Point Beach Nuclear Plant, Units 1 and 2
Dockets 50-266 and 50-301
Renewed License Nos. DPR-24 and DPR-27

License Amendment Request 261
Extended Power Uprate
Response to Request for Additional Information

LICENSE AMENDMENT REQUEST 261 EXTENDED POWER UPRATE NON-PROPRIETARY RESPONSE TO REQUEST FOR ADDITIONAL INFORMATION

Figure 16-1 RPV Support Structure Analytical Model

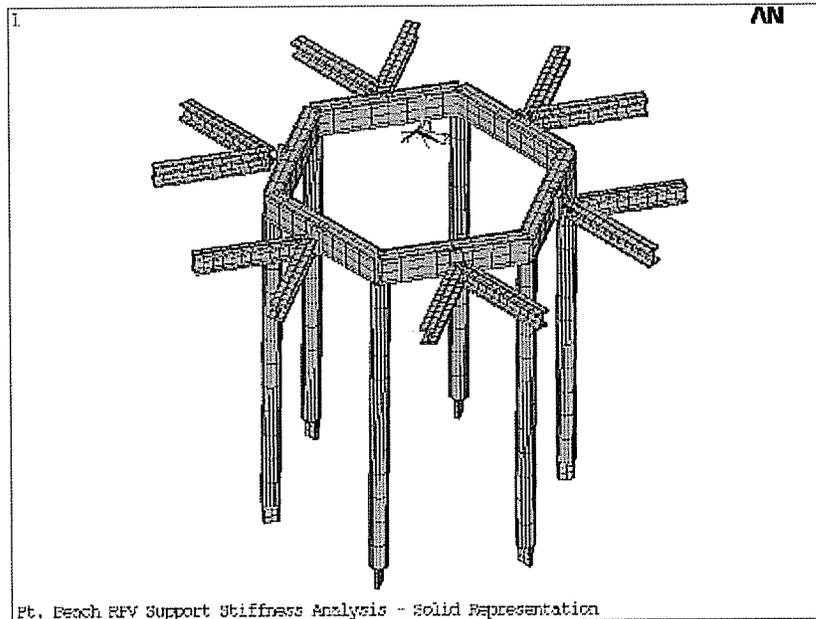
LR Table 2.2.2.3-6 contains the EPU revised "RPV support loads (per Support)."

- a) *Please explain whether these RPV loads were applied to each shoe of its support structure and discuss why the CLTP RPV support loads would change for EPU?*
- b) *Please also provide the corresponding allowable loads for the EPU revised RPV support loads, as shown in Table 2.2.2.3-6.*

During a detailed review of the RPV system model for EPU it was discovered that the vessel support stiffness used in horizontal and vertical directions did not consider the complete flexibility of the reactor vessel support system. A corrective action was initiated by Westinghouse and the potential discrepancy was addressed for the current PBNP operation as well as for the proposed EPU conditions. The RPV system analyses were performed for both seismic and LOCA conditions using the revised vessel support stiffness values in horizontal and vertical directions. This revised analysis using a more flexible reactor vessel support system produced results that were higher than the previously analyzed loads as used in the current analysis of record. Since the RPV system analysis results feed into various other analyses, including the reactor vessel supports, the new loads were shown to be higher than previously analyzed loads and were reconciled for both the current operation as well as EPU conditions. The downstream analyses were confirmed to be acceptable and within allowable limits as part of the corrective action resolution.

- b) There are four critical RPV support structural components; the support shoe, the leveling screw, the support structure pipe column and box beam. The results of the structural evaluation of these components for revised loadings under EPU conditions, in the form of stress interaction ratios, are provided in LAR 261, Table 2.2.2.3-5.

The requested allowable loads for the pipe column and box beam are not directly available as are the support shoe and leveling screw since the stress interaction ratios are based on a structural analysis of the combined support frame. The support frame analytical model is shown in Figure 16-1. The structural analysis produced critical member loads for the pipe column cross sections and the box beam cross sections. Critical or controlling member loads in the form of axial forces (tension and compression), biaxial shear forces, torsional moments, and biaxial bending moments were created. Actual member stresses were computed from the critical member loads and the corresponding cross section properties. Allowable stresses for tension, compression, shear, and biaxial bending were computed in accordance with the PBNP primary equipment support design basis requirements taken from Table A.5-3 of the FSAR. Stress interaction ratios were then computed with the axial tension and compression with biaxial bending combination equations shown in Figure 16-2 below. Shear stress interaction ratios were also computed with combined direct shear and shear due to torsion. The controlling stress ratios for the pipe column and the box beam cross sections are summarized in LAR 261, Table 2.2.2.3-5.

In summary, the structural qualification of the pipe column and the box beam for EPU conditions is demonstrated by showing that all combined actual stresses are less than the corresponding allowable stresses.
